# Master Cylinder Brake Fluid Fix

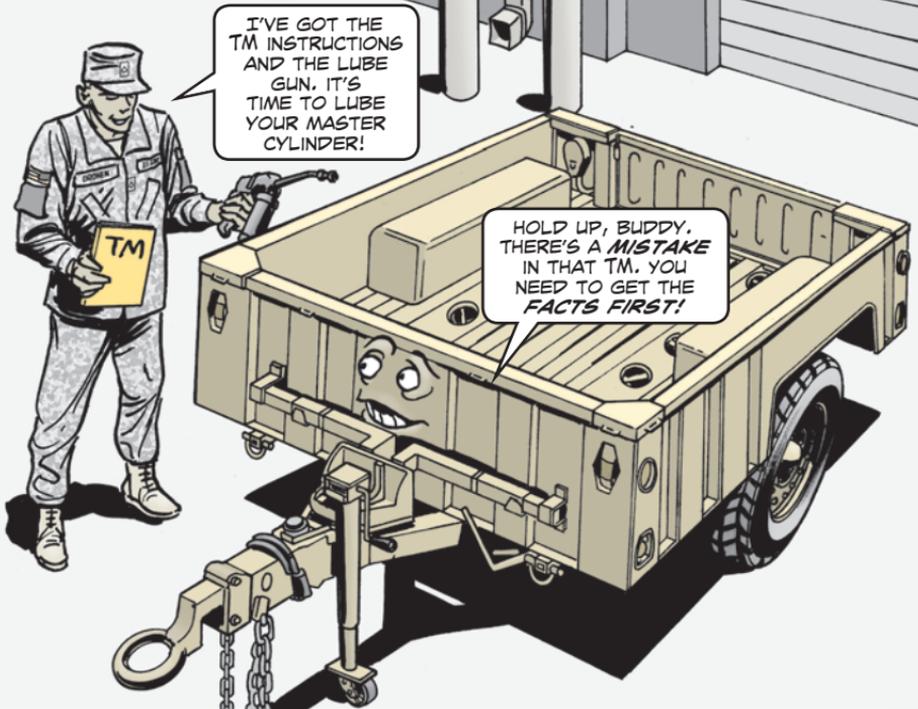
I found a mistake in TM 9-2330-392-14&P. Step 3 of the Notes section on Page G-6 in Appendix G gives lube instructions for the master cylinder. It says "semiannually, or as required, fill to within  $\frac{1}{8}$  inch (3 mm) of top edge of reservoir." But doing this won't allow for expansion of the brake fluid!

To allow for expansion, the TM should be changed to say "semiannually, or as required, fill to about  $\frac{1}{8}$  inch (3 mm) below the bottom of the reservoir filler neck."
